PIC16C923 Rev. A Silicon Errata Sheet

The PIC16C923 (Rev. A) parts you have received conform functionally to the Device Data Sheet (DS30444D), except for the anomalies described below.

FIGURE 1: WRITES TO TIMER1 (EXTERNAL CLOCK / OSCILLATOR MODE)

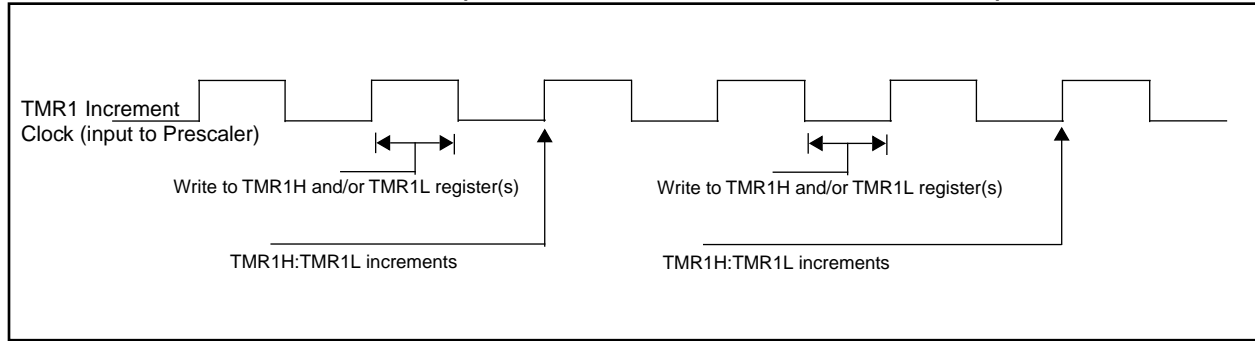
- a) The operation of Timer1 needs some clarification when the timer registers are written when the TMR1ON bit is set.

The internal clock signal that is the input to the TMR1 prescaler affects the incrementing of Timer1 (TMR1H:TMR1L registers and the Timer1 prescaler). When the Timer1 registers are NOT written, the Timer1 will increment on the rising edge of the TMR1 increment clock.

When the TMR1H and/or TMR1L registers are written while this clock is high, TMR1 will increment on the next rising edge of this clock.

When the TMR1H and/or TMR1L registers are written while this clock is low, TMR1 will not increment on the next rising edge of this clock, but must first have a falling clock and the the rising clock for TMR1 to increment.

Figure 1 shows the two cases of writes to the TMR1H and/or TMR1L registers. Due to the V_{IH} and V_{IL} thresholds on the oscillator/clock pins, external Timer1 oscillator components, and external clock frequency, the Timer1 increment clock may not be of a 50% duty cycle.

The TMR1 increment clock is out of phase of the T1OSO/T1CKI pin by a small propagation delay.
